AGENDA
BUDGET & FINANCE COMMITTEE MEETING
Tuesday, September 14, 2021 at 7:00 p.m.
N168 W20733 Main Street
Jackson, WI 53037

SECTION 00 63 63
CHANGE ORDER

Change Order No. 10

A DETAIL VIEW

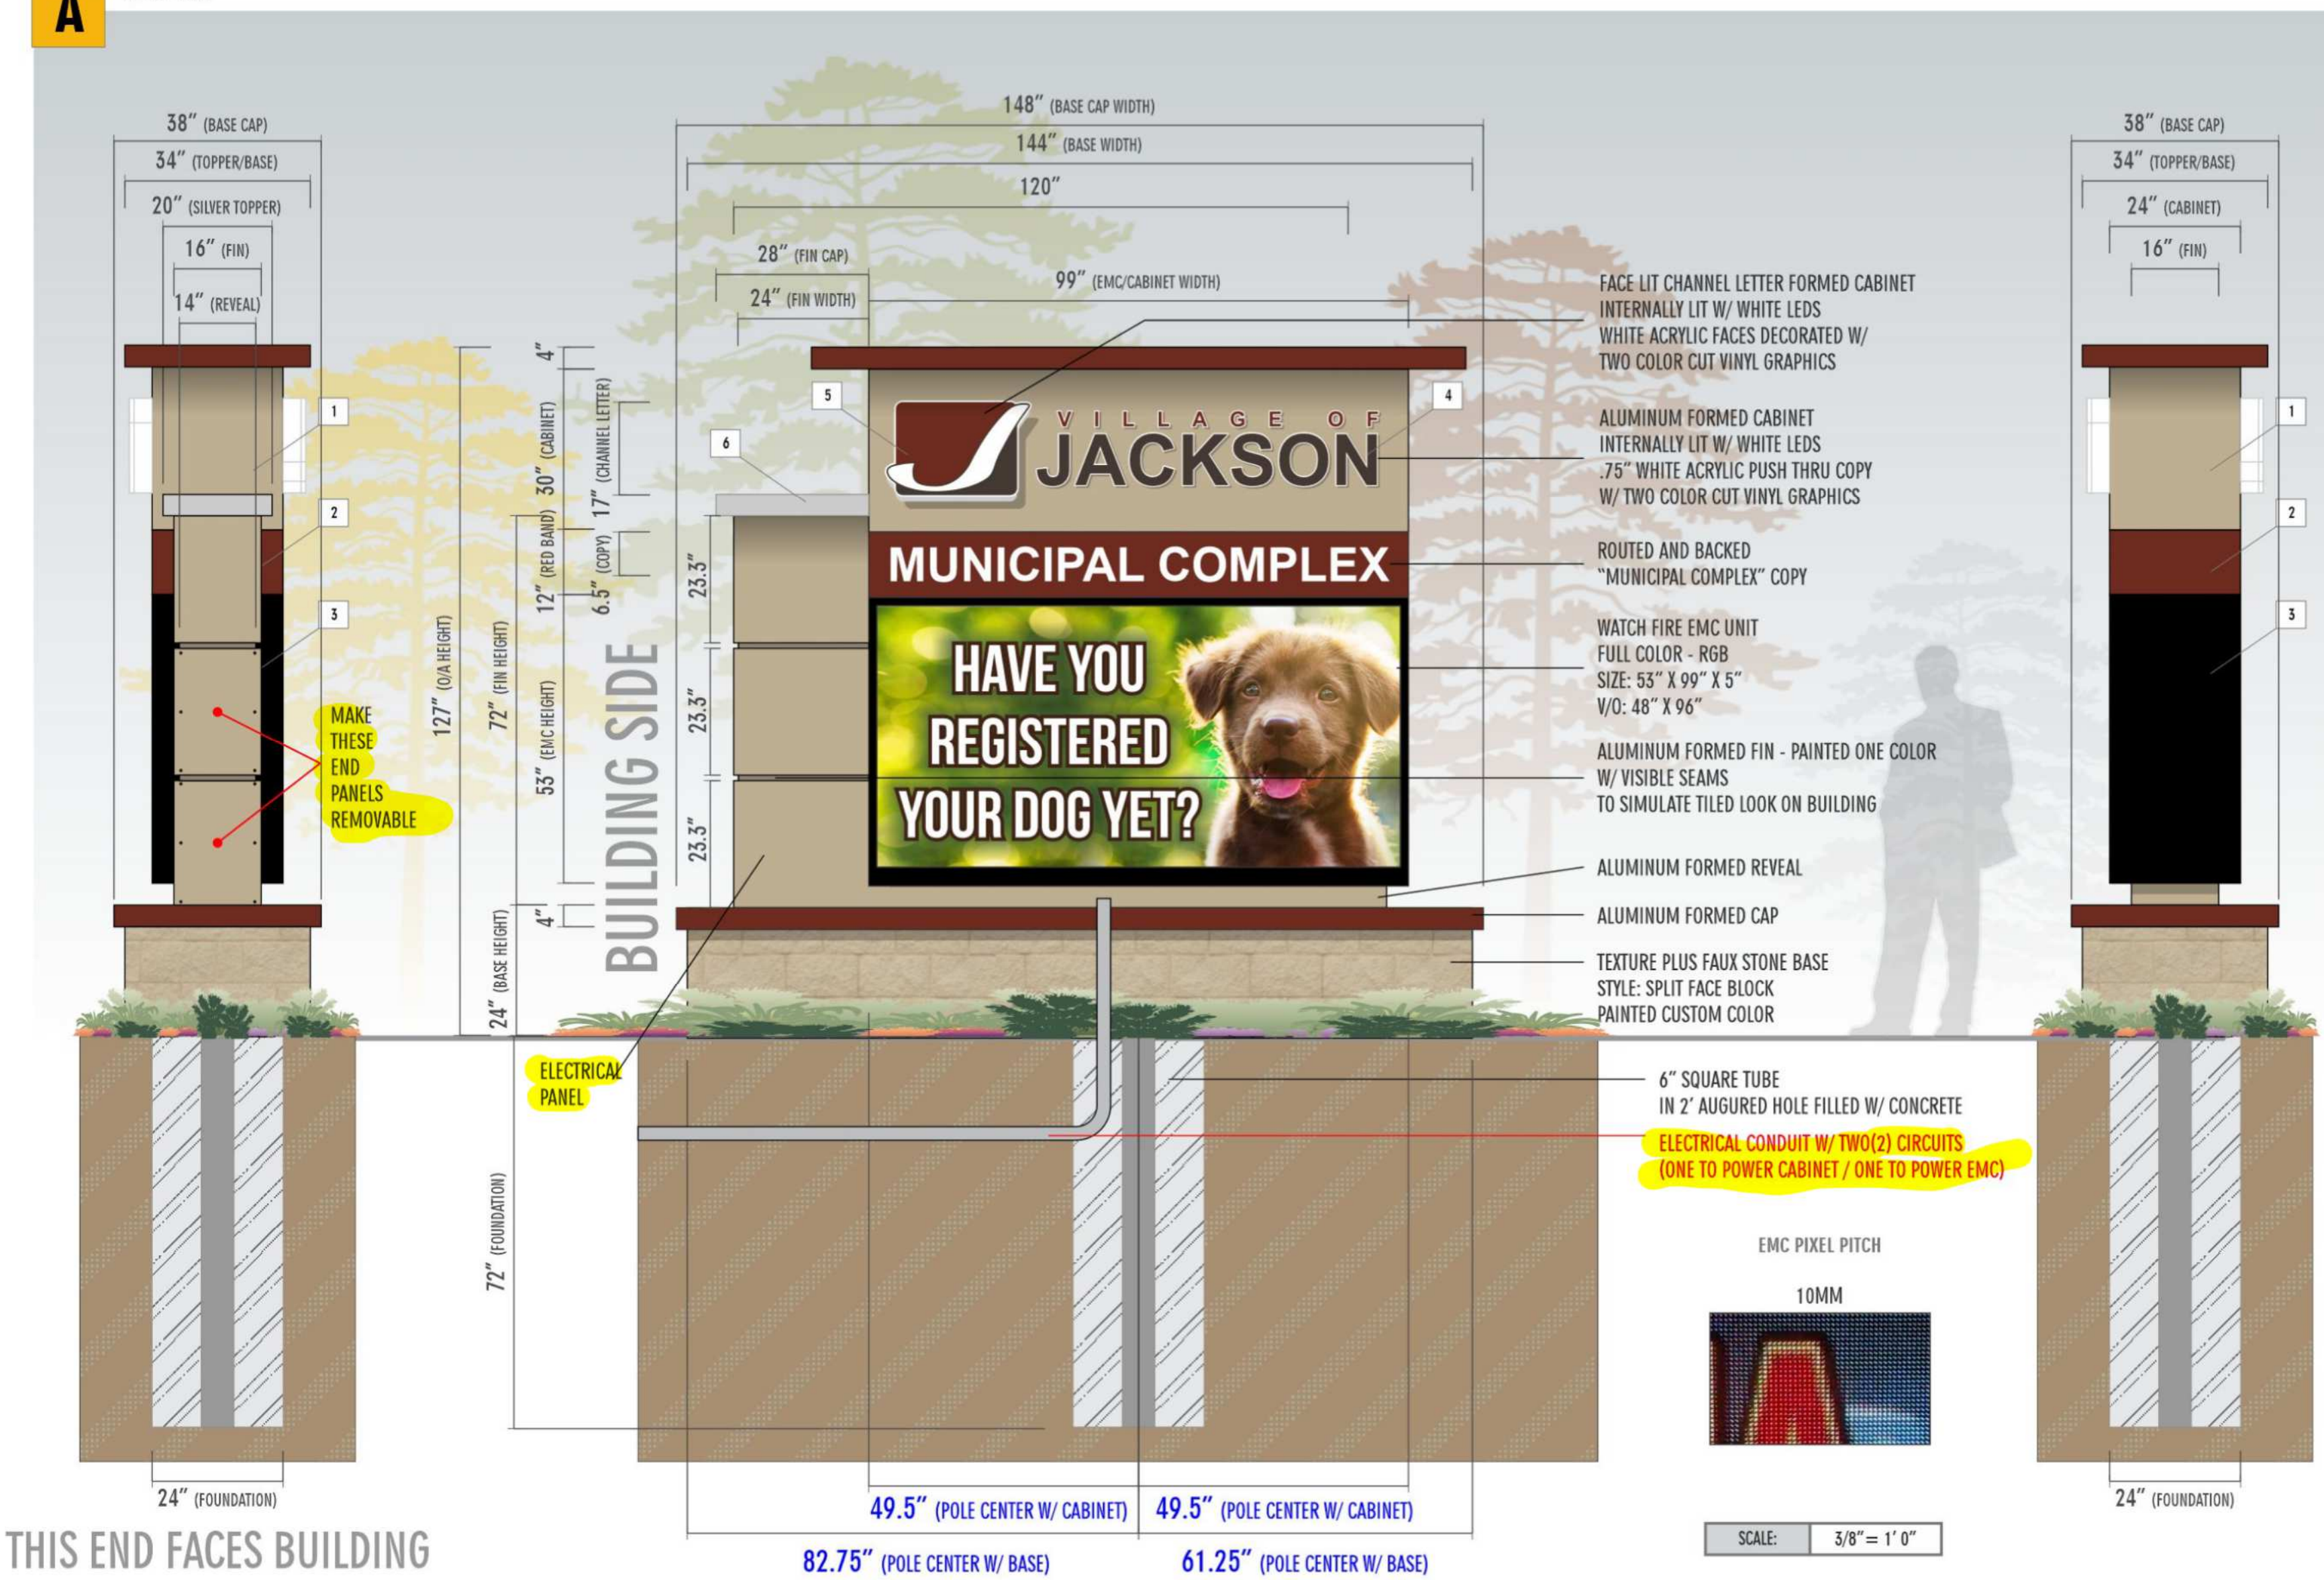
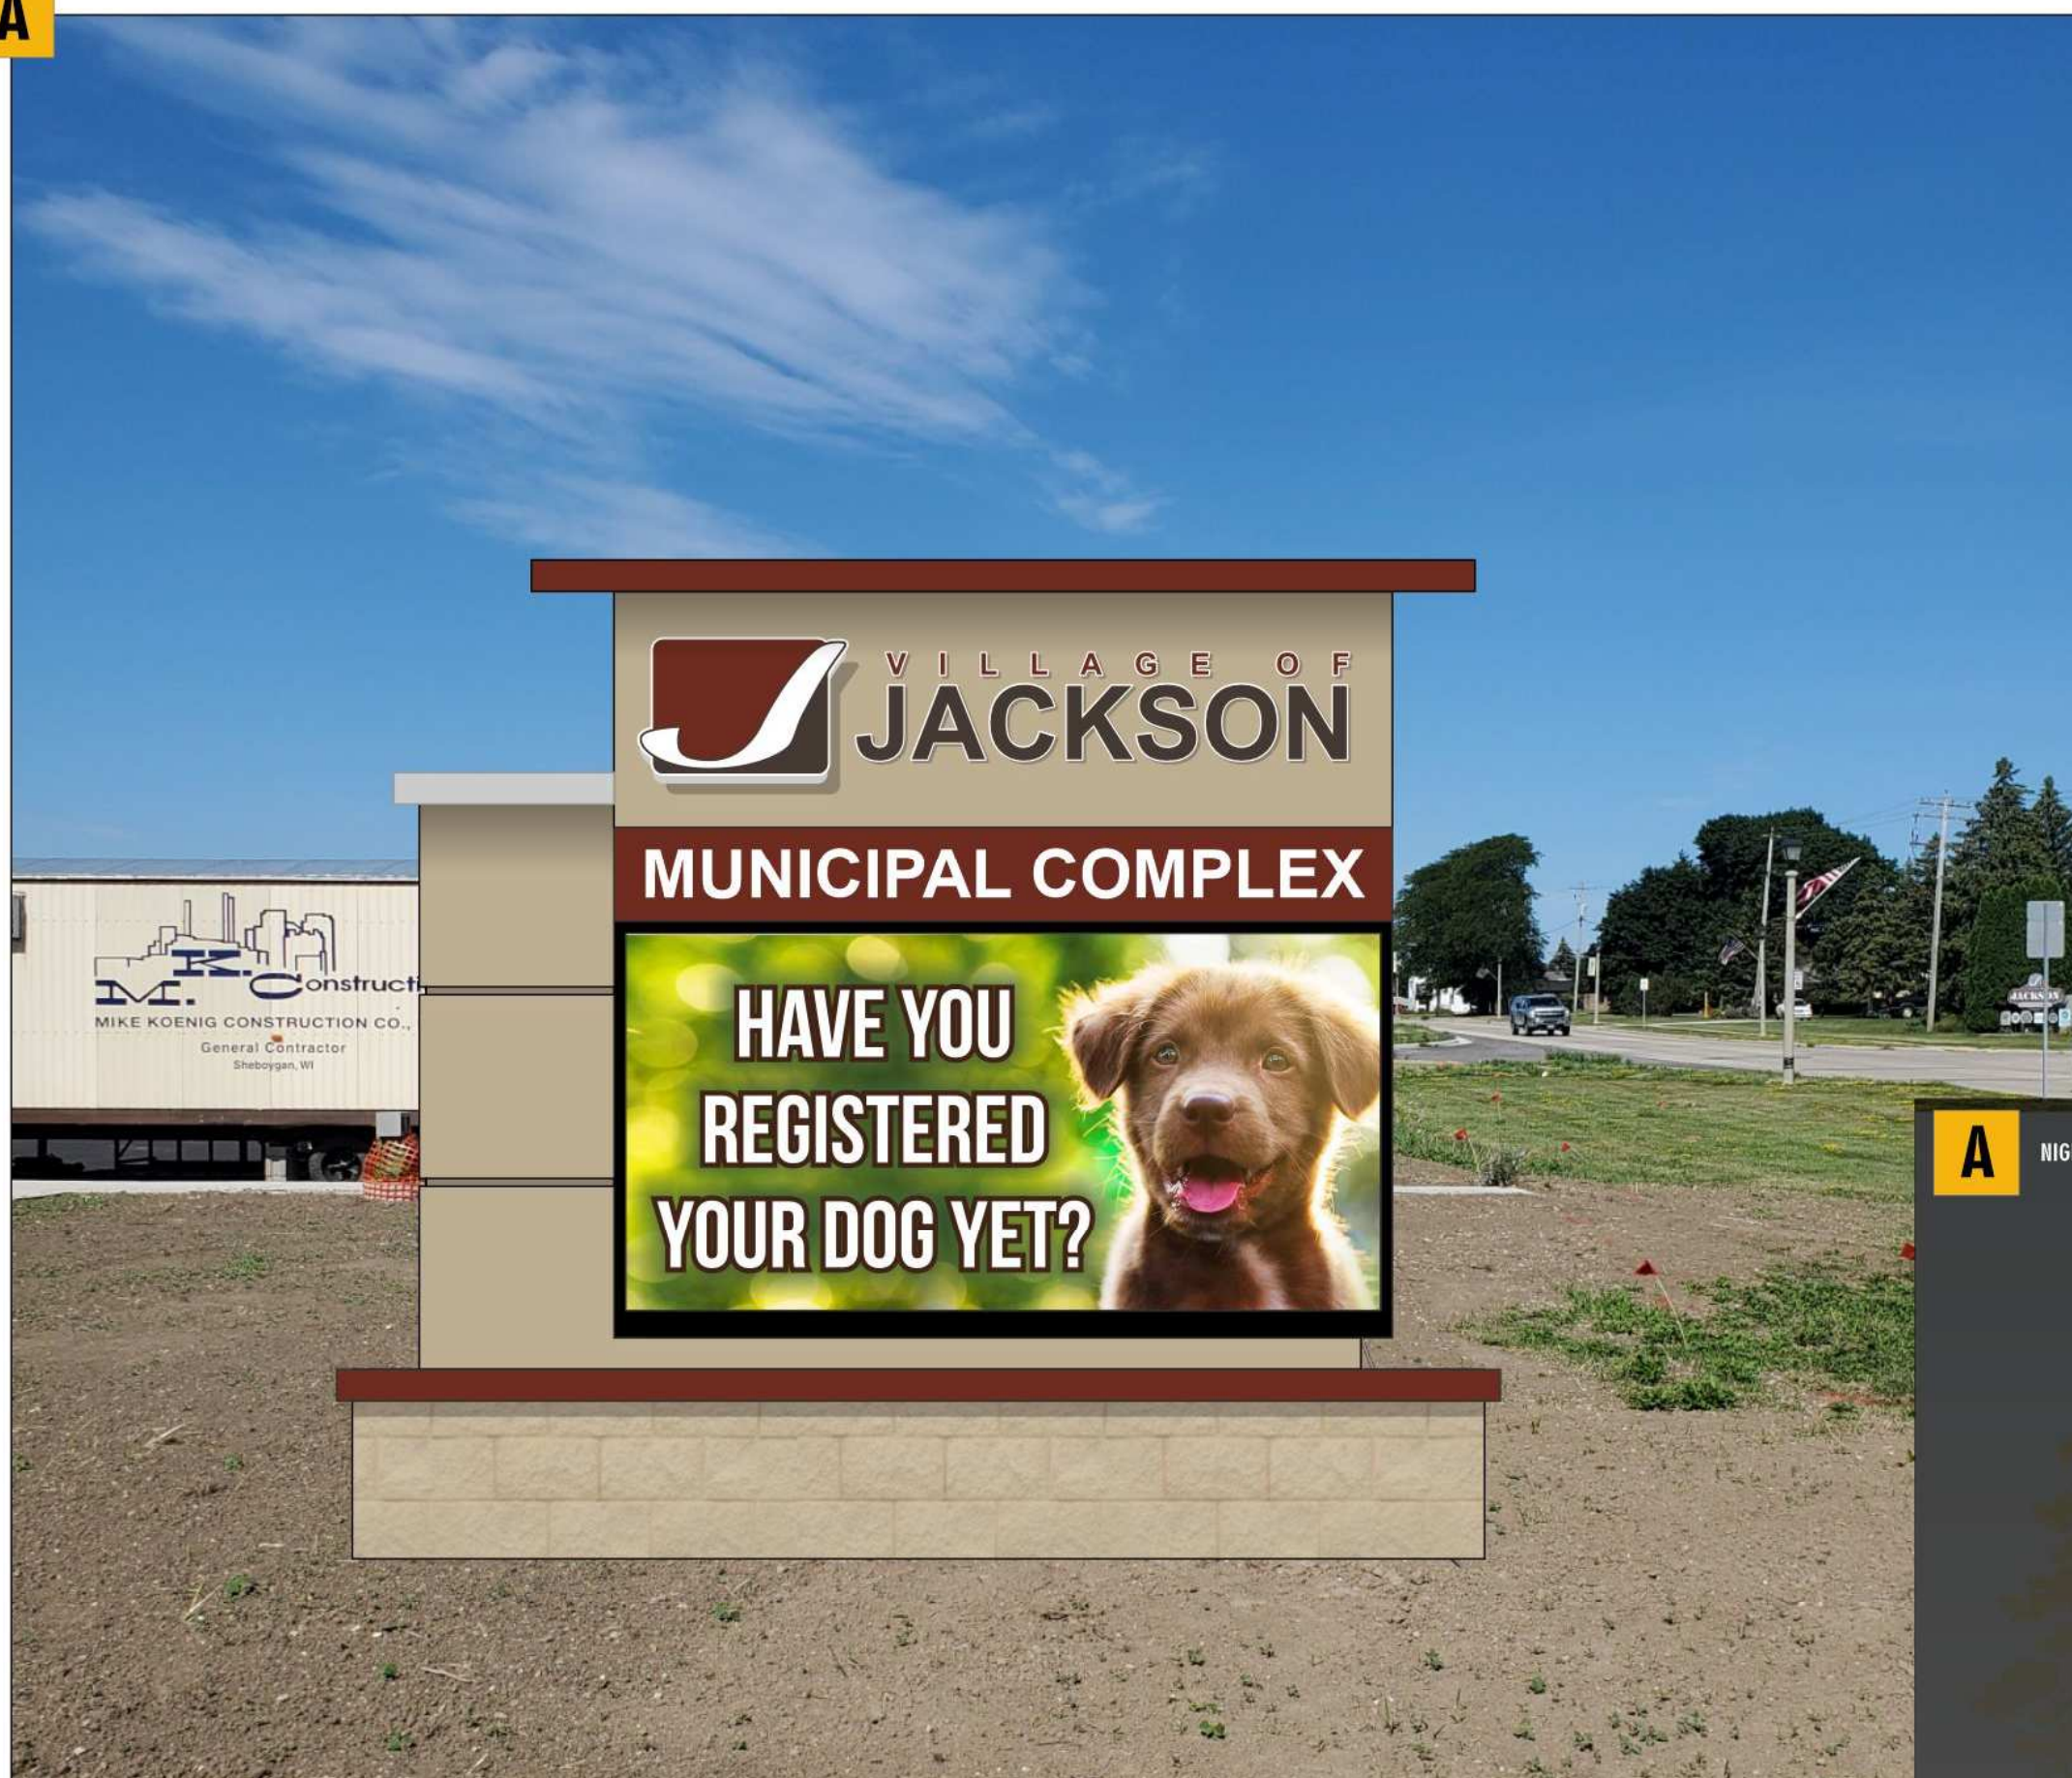
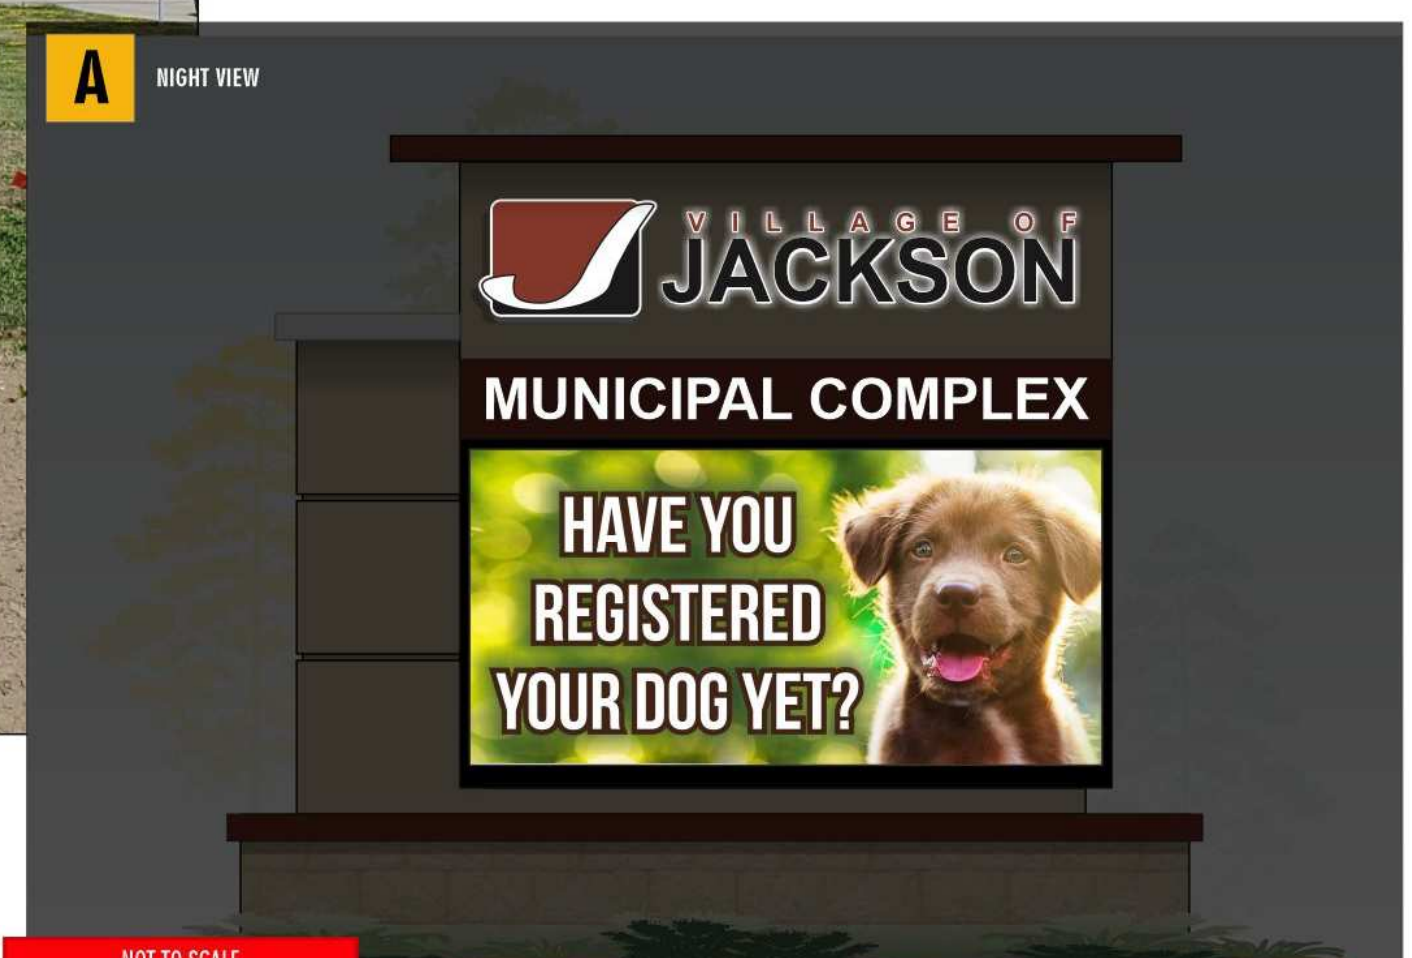
Addition of the furnishing and installation of circuit wiring and equipment components associated with the Owner provided Monument/Pylon signs. Work was initially removed from within the contract scope and then again added by the Owner upon finalizing the sign design and resolution.

Please provide a lump sum cost proposal related to the all-inclusive installation of electrical circuit wiring for the proposed Pylon Sign. Attached please find detailed information related to the scope of the work. Please base your proposal on this information.

15. RUN A 208/120 VOLT 1 PHASE 3 WIRE 60 AMP CIRCUIT IN THE EXISTING 1" CONDUIT TO THE PYLON SIGN PANEL. PROVIDE A 208/120 VOLT 1 PHASE 3 WIRE PYLON SIGN PANEL WITH (1) 120V 20A/1P BREAKER AND (1) 120V 40A/1P BREAKER LOCATED INSIDE PYLON SIGN. WIRE THE 20 AMP AND 40 AMP PYLON SIGN CONNECTIONS IN THE PANEL.

- Install electrical panel mounted in sign NEMA 1R
- Provide and install sign wiring
- Sign controls are wireless
